**RE: Dollar General Store
Preliminary Plan Review for Dollar General
Eagle, Wisconsin**

Engineering Review Memo by Lynch and Associates; dated August 4th, 2020

FINAL ENGINEERING PLANS

A2.1
EXTERIOR
ELEVATIONS

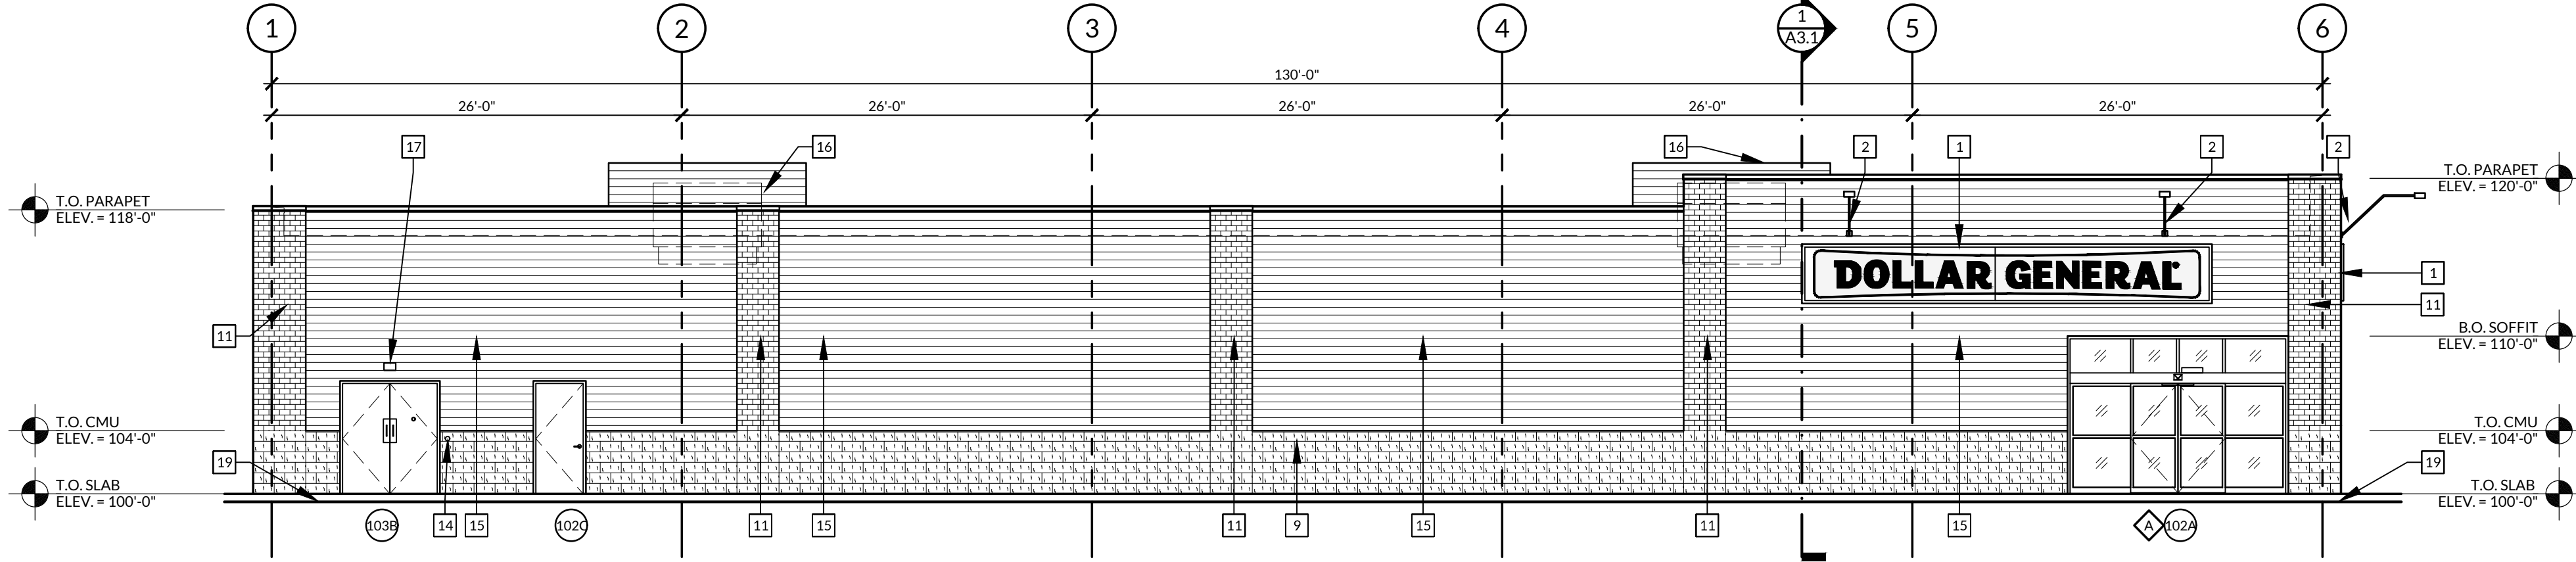
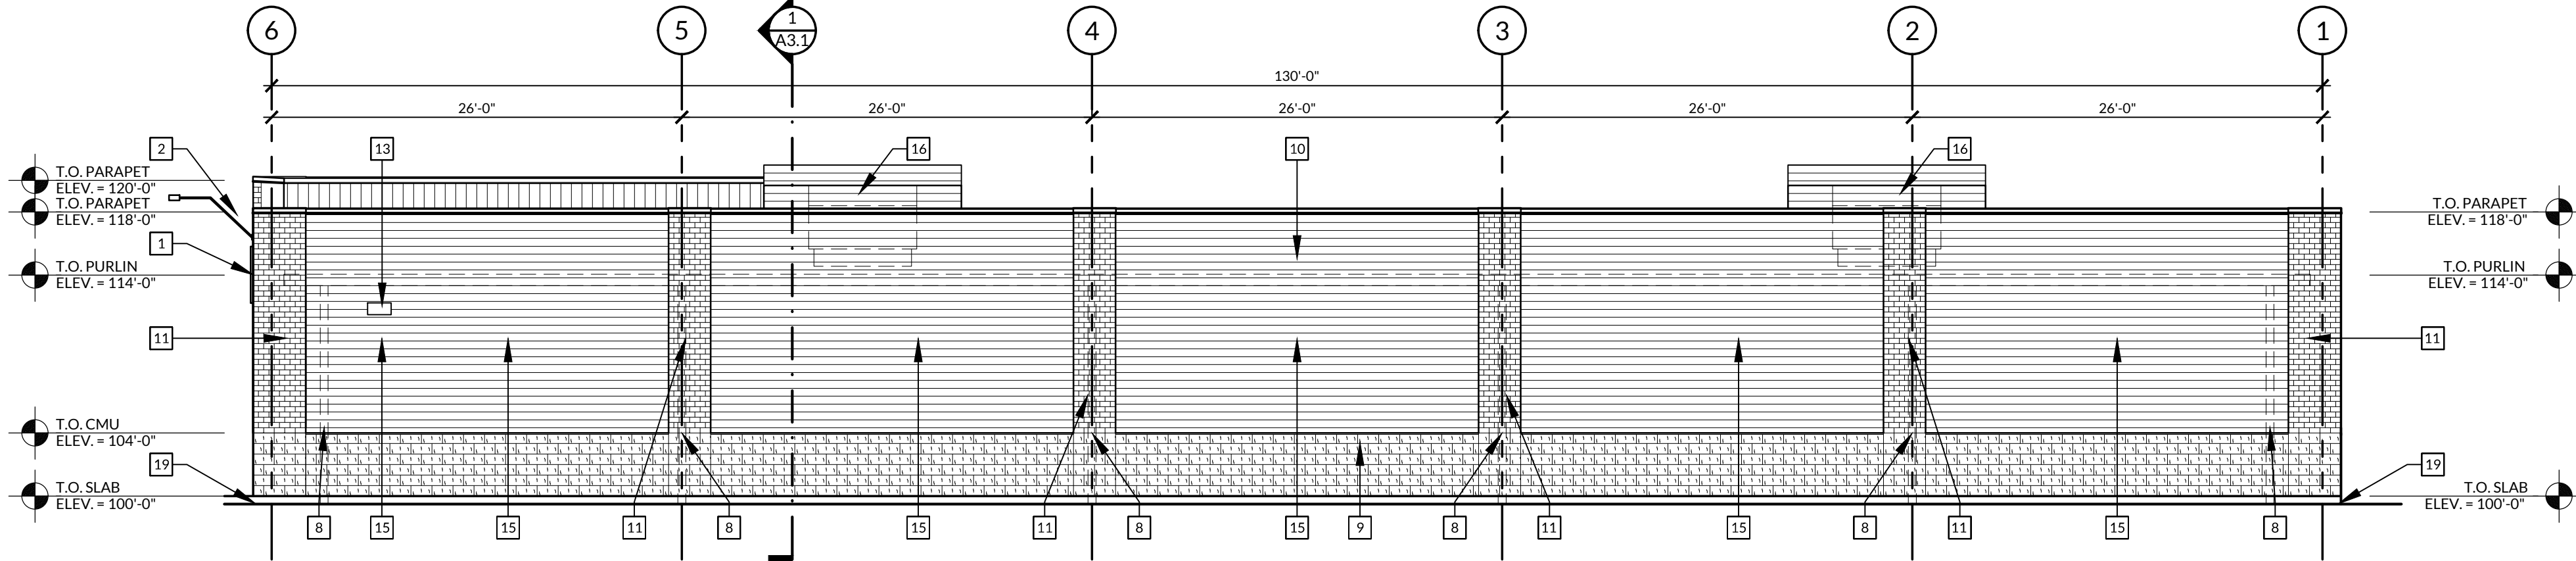
1. Provide Masonry building materials on the east elevation.
Response: All four elevations of the building are now masonry – see revised elevations.
2. Provide pilasters on the east elevation to break up the façade.
Response: Vertical elements and pilasters have been provided on the revised building elevations.
3. Provide a parapet wall on the east elevation.
Response: A parapet wall has been provided on the east elevation. – See revised elevations.
4. Provide 8" deep by 12" wide pilasters per Town Code.
Response: The necessary depth and width of pilasters has been provided – See Site Plan.

5. Move the entry door on the west elevation to encourage parking on the west side of the building.
Response: The entry door has been moved to the west elevation – See Site Plan.

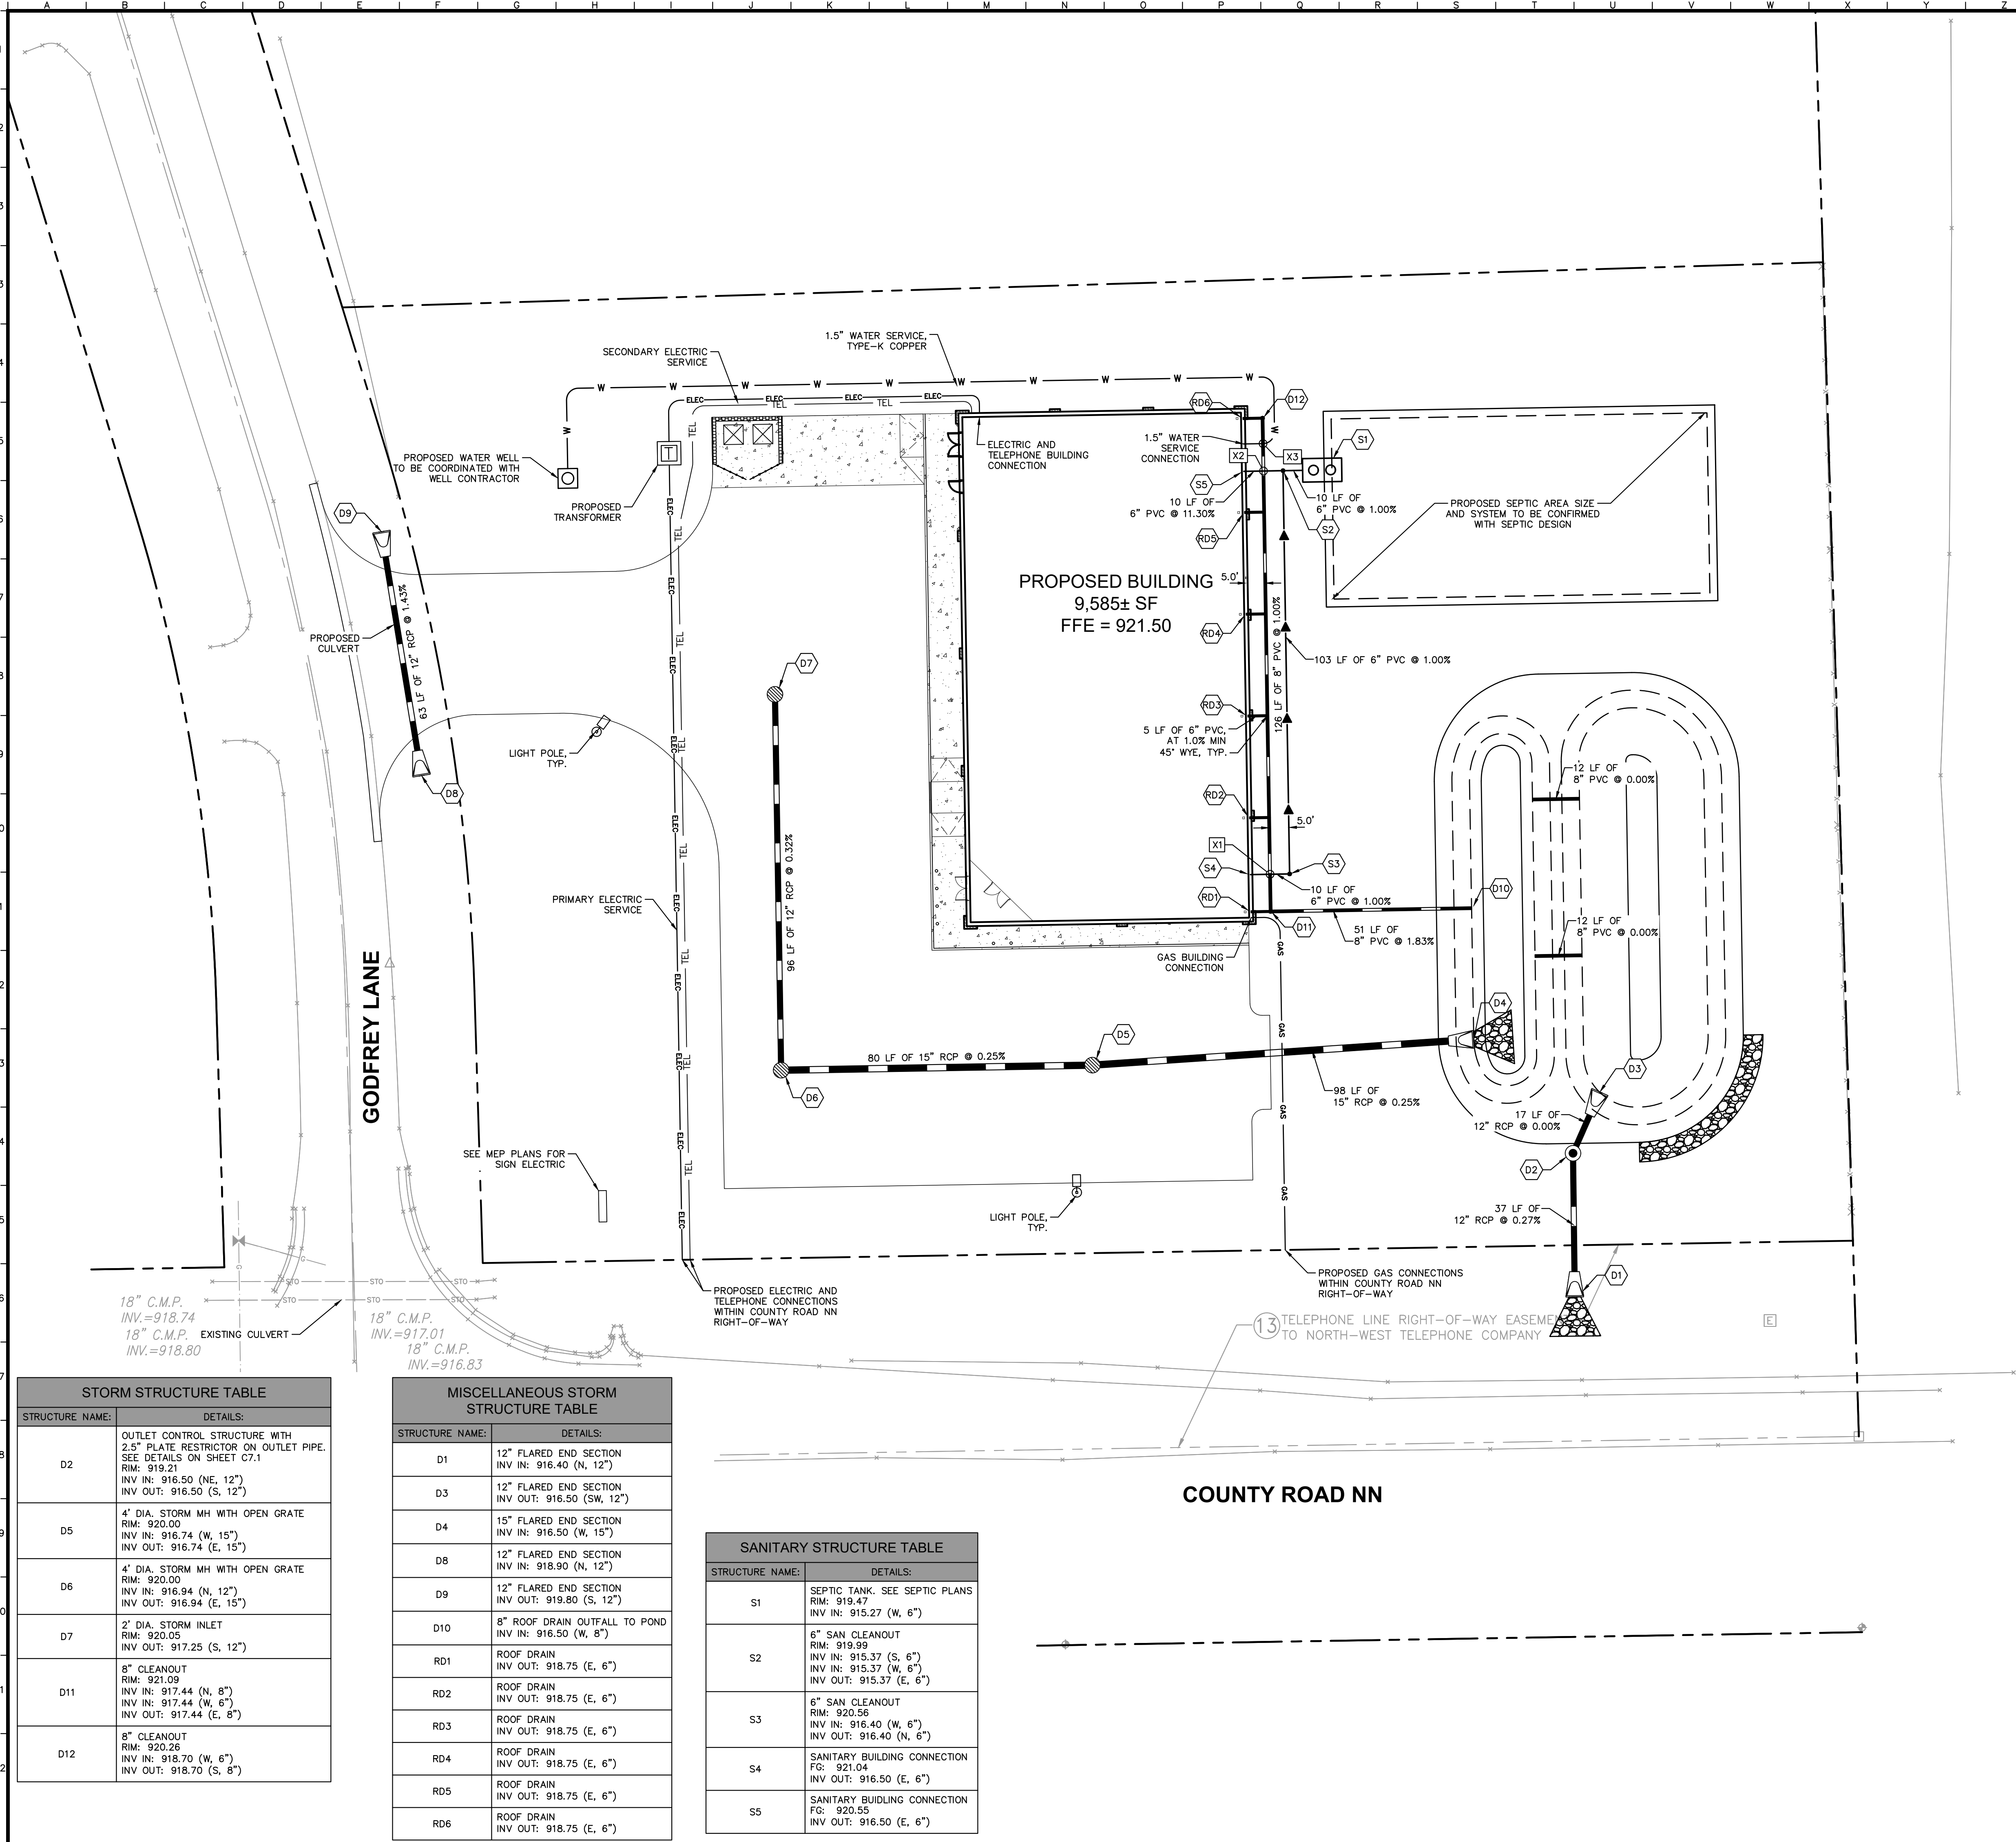
Response: Pavement sections for asphalt and sidewalk have been included on sheet C7.0.
2. Verify the building FFE. The plan elevation and cross section elevation are different.

Response: The FFE is 921.50, which has been corrected on the Plan and Cross Section on Sheet C5.0.
3. The top of curb and flowline elevations appear to be reversed along the front edge of the walk.

Response: Top of curb and flowline elevations have been revised to show correct values. See Sheet C5.0.
4. Label proposed pipe with pipe diameter, pipe type, and length on C2.0.

Response: Sanitary and storm pipes have been labeled accordingly, see Sheet C6.0.
5. The sidewalk along the building is less than 1% in slope and the slope should be increased to provide better drainage away from the building.

Response: The proposed sidewalk grades along the building have been revised to increase the slope to a value greater than 1%, but less than 2.0%. See sheet C5.0.

6. The drainage away from the rear of the building does not meet requirements of SPS 321.12.
Response: The drainage away from the rear of the building has been increased above 0.5" per 12" (4.167%) for at least the first 10 feet. See Sheet C5.0.
